Your ref  
Y19/1408/FH

**Proposal:** Change of use and conversion of existing vacant bank to an office (Class B1) and residential flat on ground floor and four self contained flats on the upper floors. Erection of rear extension containing three self contained flats.

**Site:** Y19/1408/FH: -Natwest, 48 Cheriton High Street, Folkestone, Kent, CT19 4HB.

Southern Water MapGuide Browser

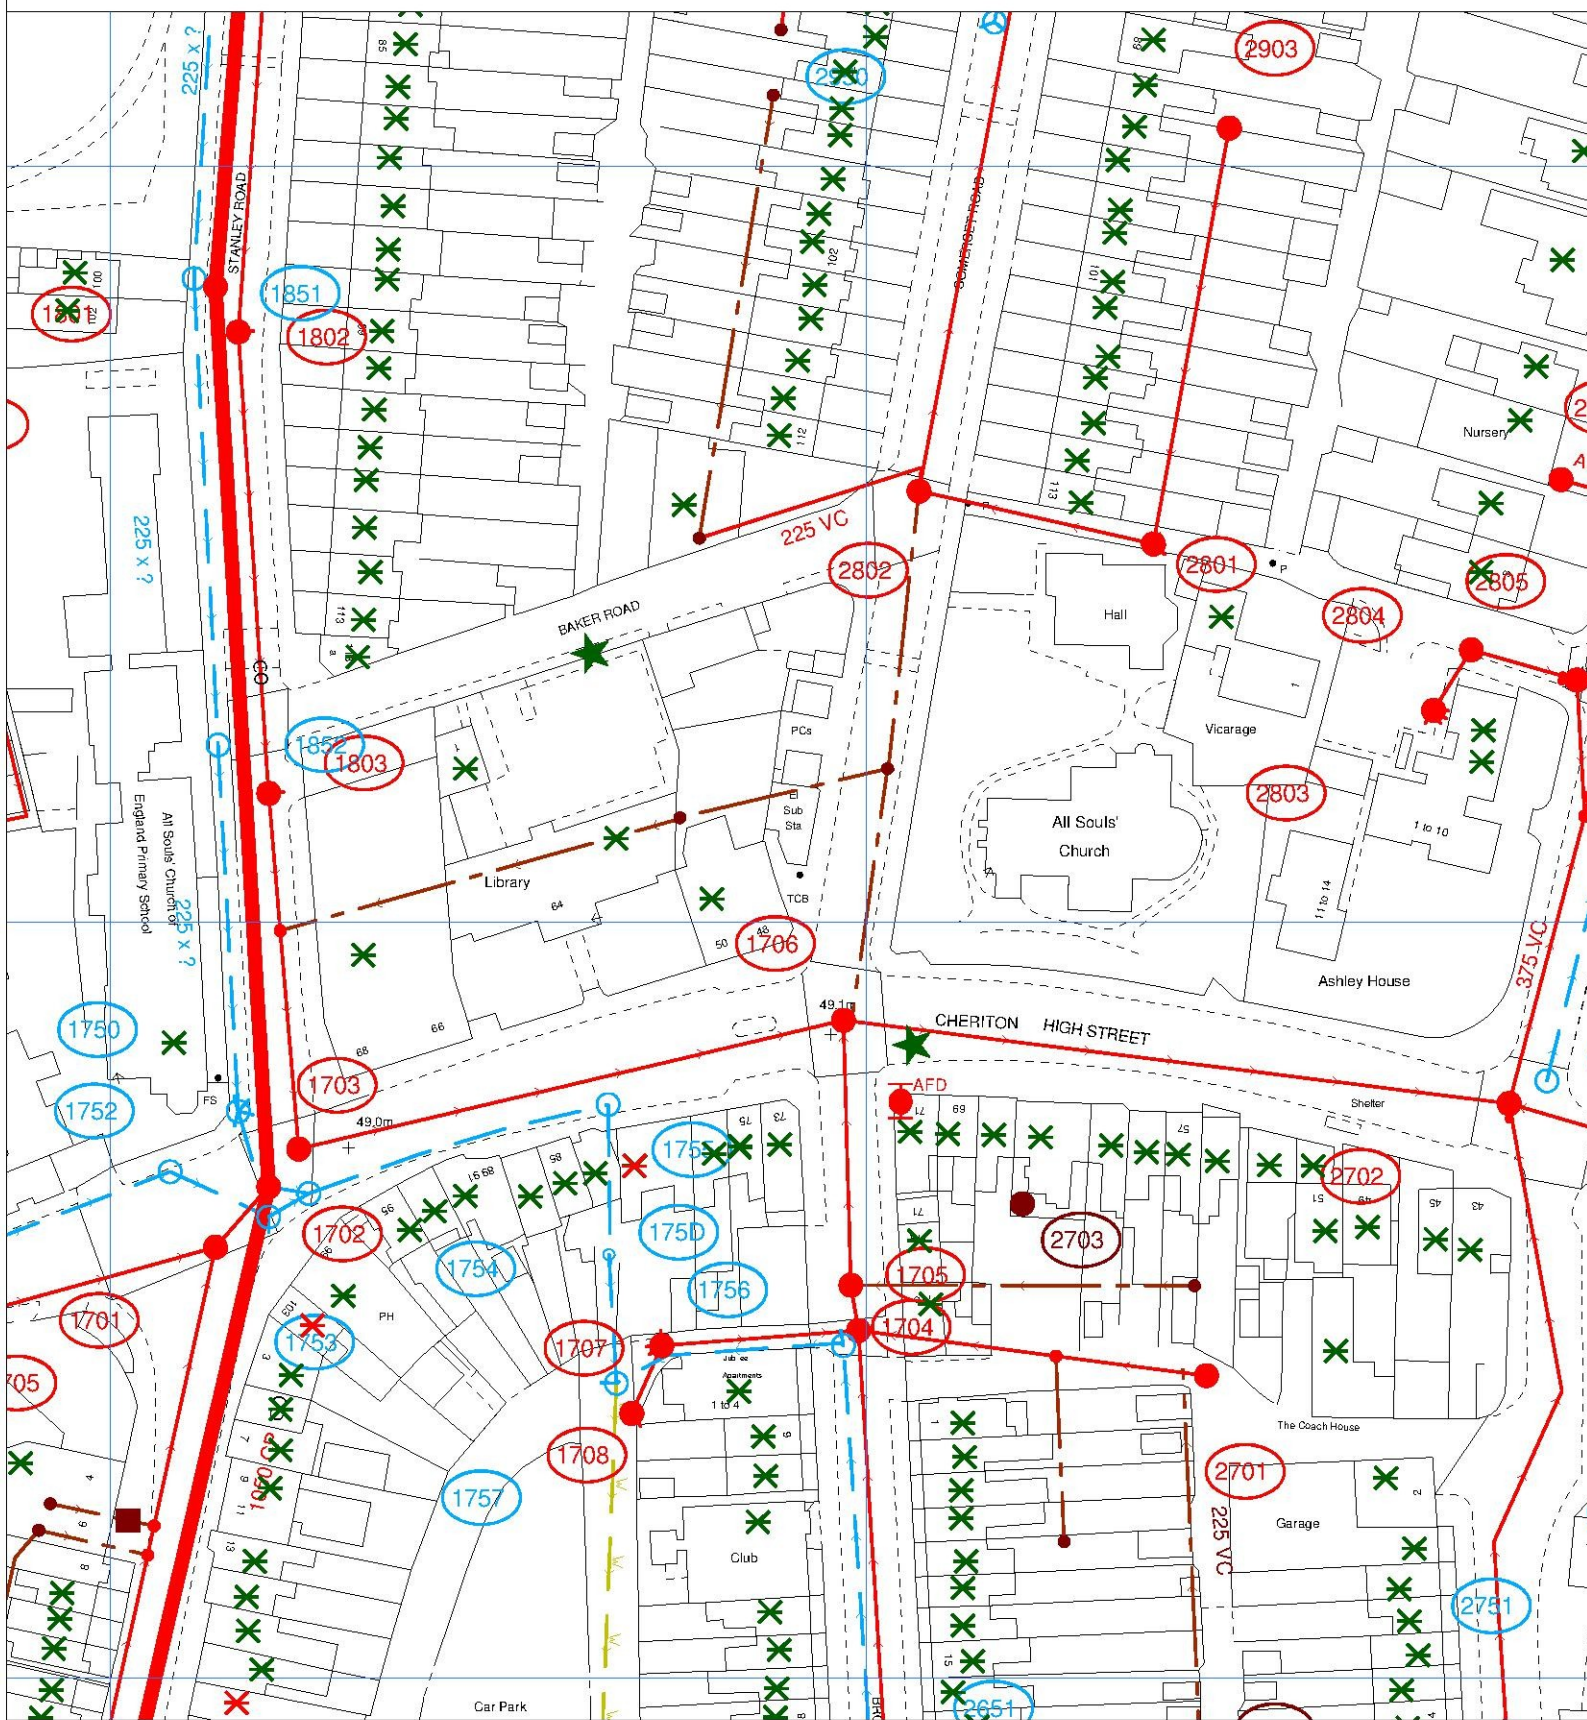
The attached plan shows that the proposed development will lie over an existing public foul sewer which will not be acceptable to Southern Water. The exact position of the public sewer must be determined on site by the applicant before the layout of the proposed development is finalised.

- The public foul sewer requires a clearance of 3 metres on either side of the gravity sewer to protect it from construction works and to allow for future access for maintenance.
- No development or tree planting should be carried out within 3 metres of the external edge of the public gravity sewer without consent from Southern Water.
- No new soakaways should be located within 5 metres of a public sewer.
- All existing infrastructure should be protected during the course of construction works.

It might be possible to divert the sewer, so long as this would result in no unacceptable loss of hydraulic capacity, and the work was carried out at the developer's expense to the satisfaction of Southern Water under the relevant statutory provisions.

Alternatively, the applicant may wish to amend the site layout, or combine a diversion with amendment of the site layout. If the applicant would prefer to advance these options, items above also apply.

In order to protect drainage apparatus, Southern Water requests that if consent is granted, a condition is attached to the planning permission; for example, the developer must advise the local authority (in consultation with Southern Water) of the measures which will be undertaken to divert the public sewers, prior to the commencement of the development.
